City of Biddeford
Planning Board
August 16, 2023 6:00 PM City Hall
Council Chambers, & Zoom
<https://biddeford.zoom.us/j/94983531202?pwd=Q3ZyejcyUVpBaUVVMHduYXJhSzB4UT09>
Webinar ID 949 8353 1202; Passcode 223739

- 7. NEW BUSINESS**
 - 7.A. 2023.29 Public Meeting and take comments regarding Phase I of a Preliminary Subdivision Plan Application for One Diamond Development, LLC to construct 477 residential units, multi-unit buildings and commercial space at 1 Diamond Street (Tax Maps 40 & 37, Lots 25-1,25-2,24,25,34 & 35) in the B1 & GD1 and in the shoreland overlay zone.

[2023.29 One Diamond Master Plan and Phase 1 PRELIMINARY PLAN Planners Report 2 8-10-23.pdf](#)
[One Diamond Site Plan Application Materials 2023-06-14 18462.pdf](#)
[One Diamond - Full Plan Set to City of Biddeford 2023-06-14 18462_Reduced \(2\).pdf](#)
[2023-08-01_Diamond Match Phase 1 Preliminary Submittal - PW Comments.pdf](#)
[Response to Public Works Comments recieved 08-03-2023.pdf](#)
[Galbraith 08-10-23.pdf](#)
[One Diamond SLODA 2023-06-14 18462.pdf](#)

SHEET 32 OF 51

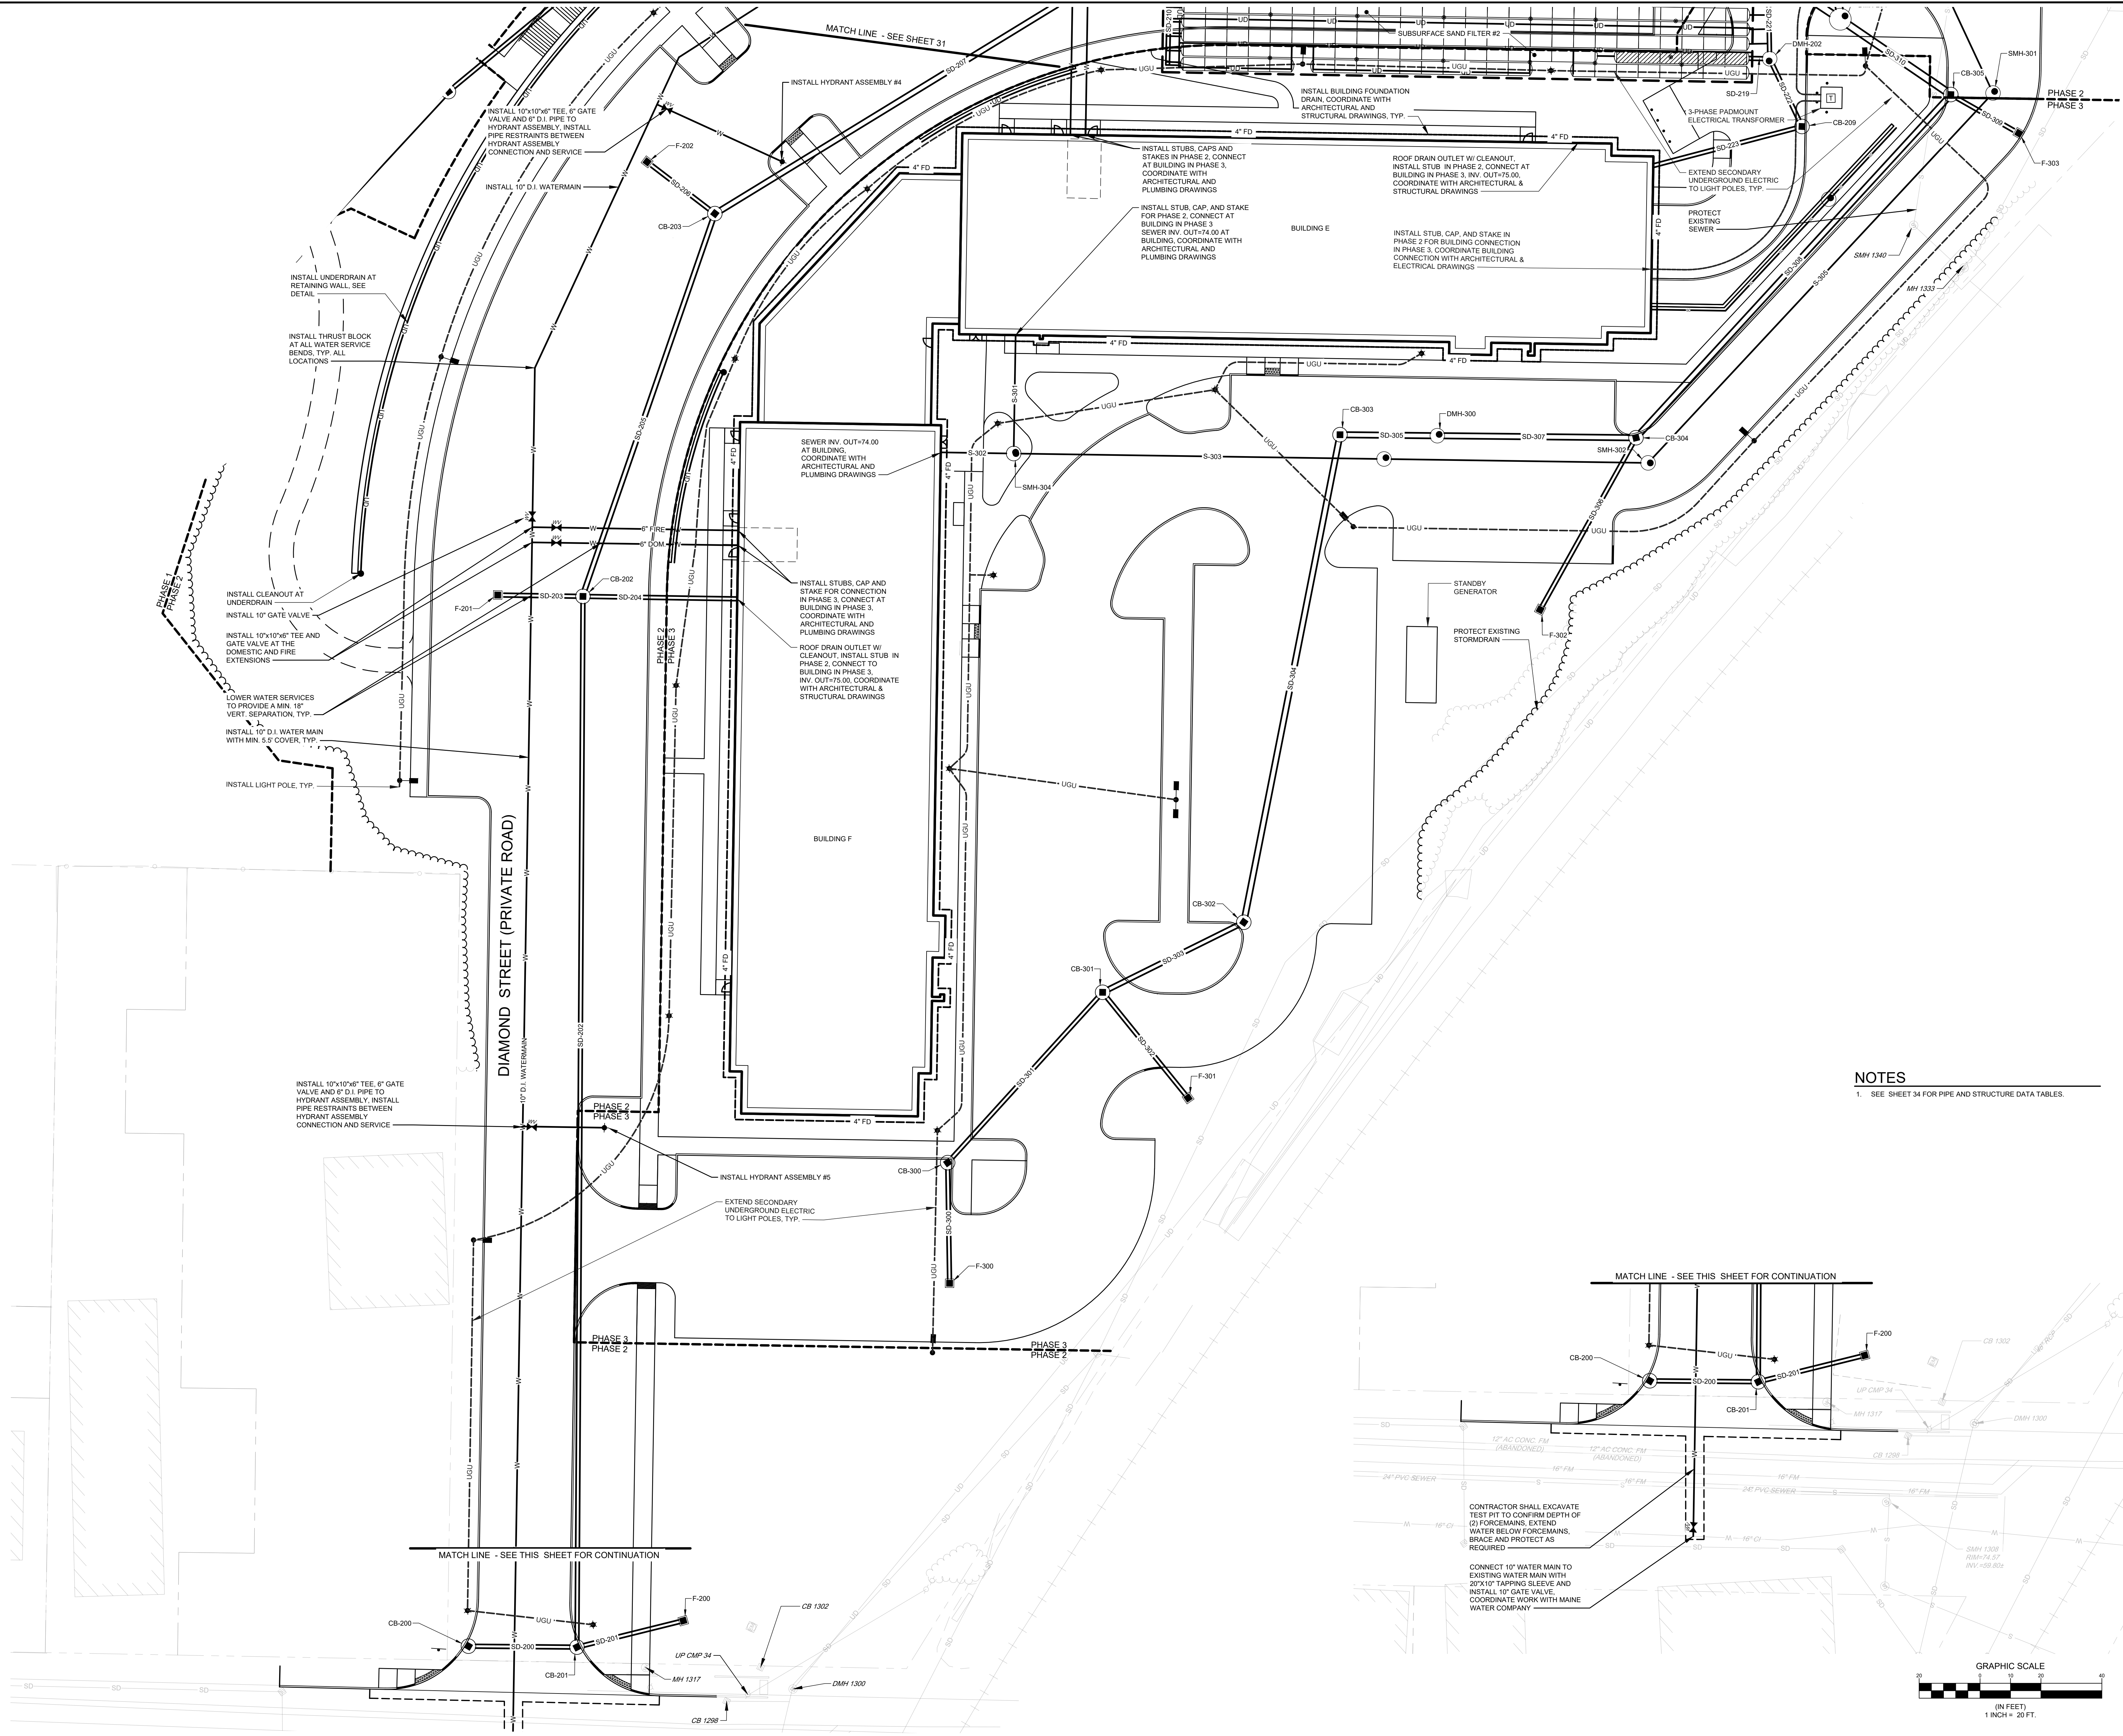
- b. *I thought Building E&F are Phase 3? (sheet 32)*

Sheet 32 will be revised to include notation clarifying the phase limits. The proposed phasing is presented on Sheet 4 of the plan set.
